Subject: FW: Resolution Island PDF Documents

CLEAN UP OF ABANDONED POLE VAULT MILITARY SITE

BAF-5 RESOLUTION ISLAND

TIER II LANDFILL
MISCELLANEOUS DETAILS

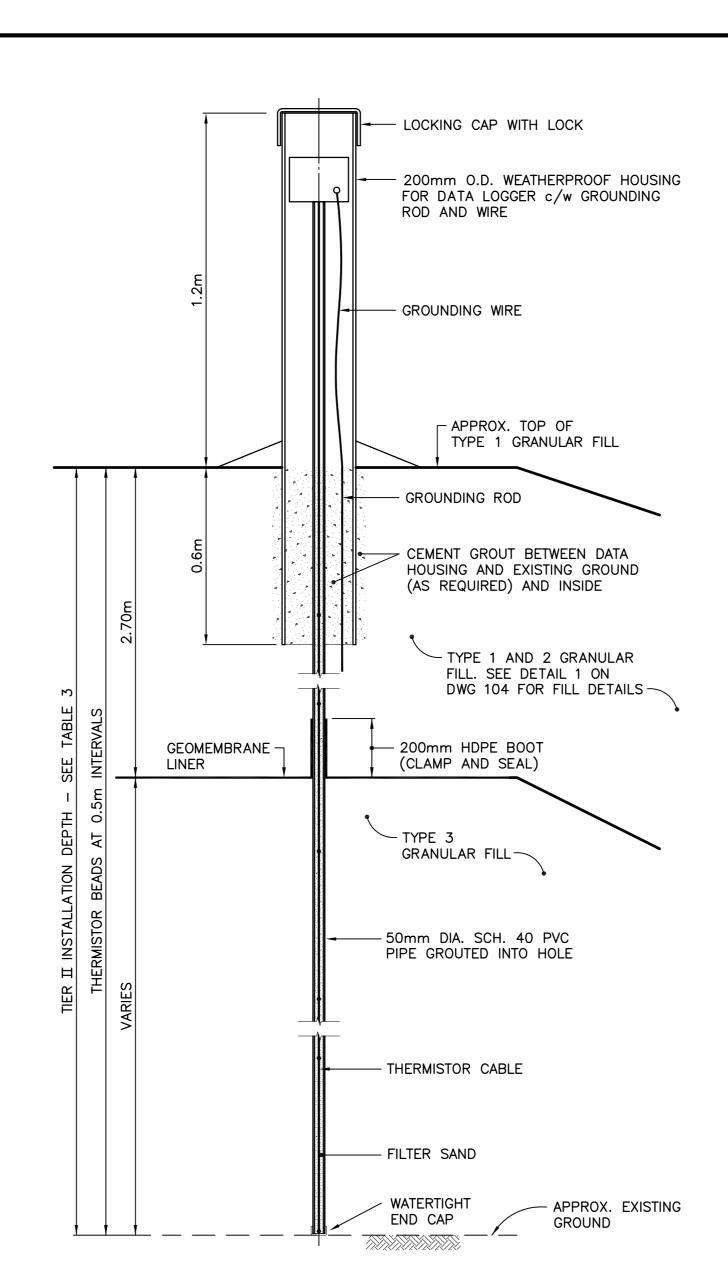
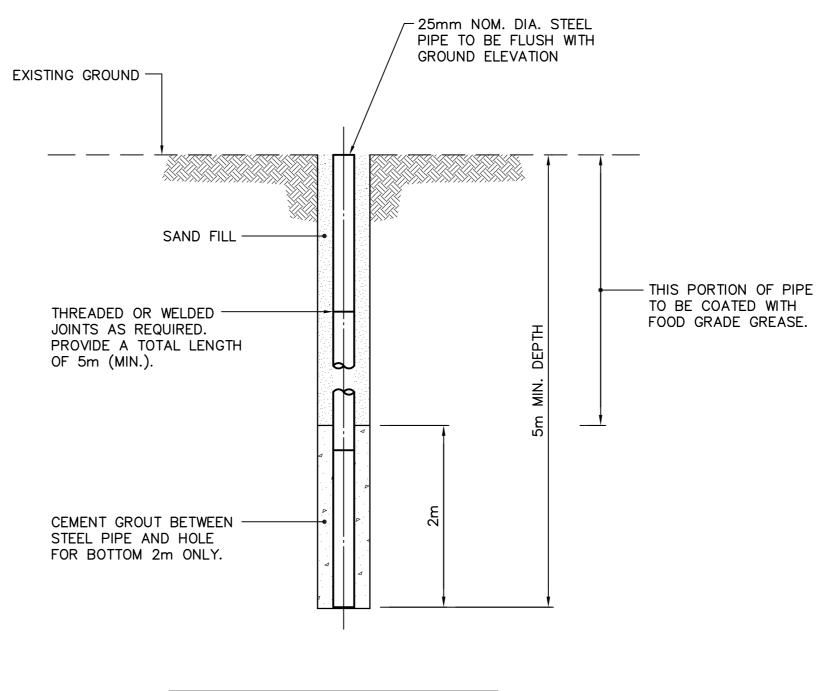
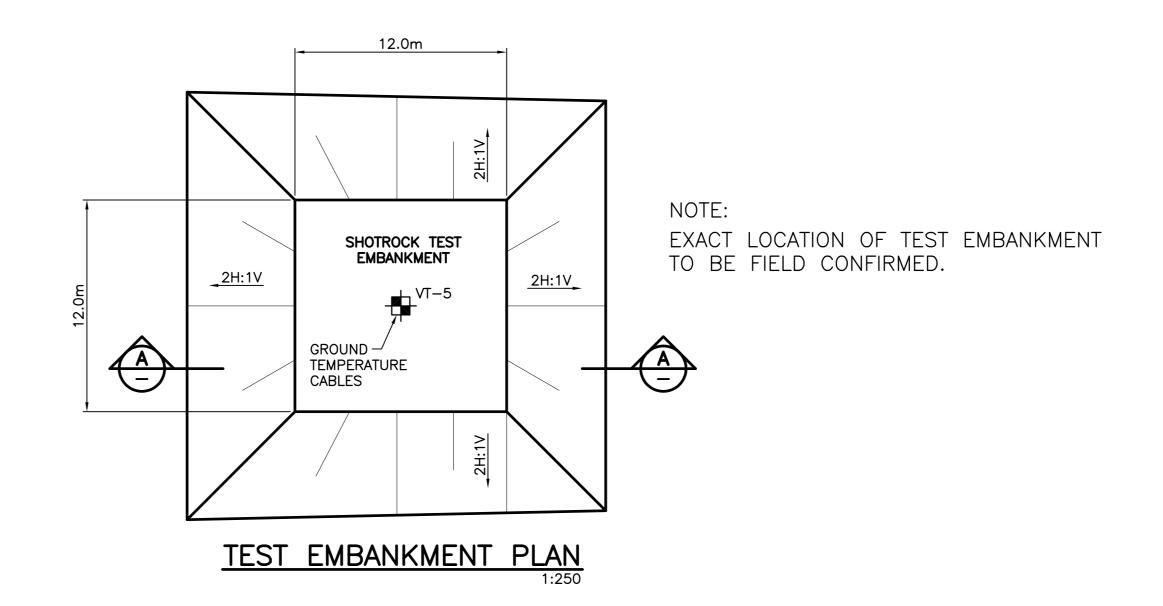
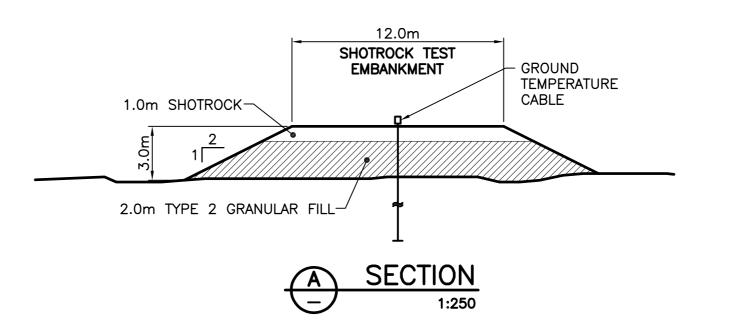
As requested by Glen Stephens, attached for information are the TIER II Landfill Drawings prepared by UMA and EBA in June, 2003. These drawings should address your questions regarding the cross section for the landfill and the locations of monitoring wells and thermistors.

In answer to your question regarding TIER I soil, TIER I soil will be placed above the TIER II soil but contained within the liner as shown on Drawing 104.TIER I soil will not be used in the berm construction.
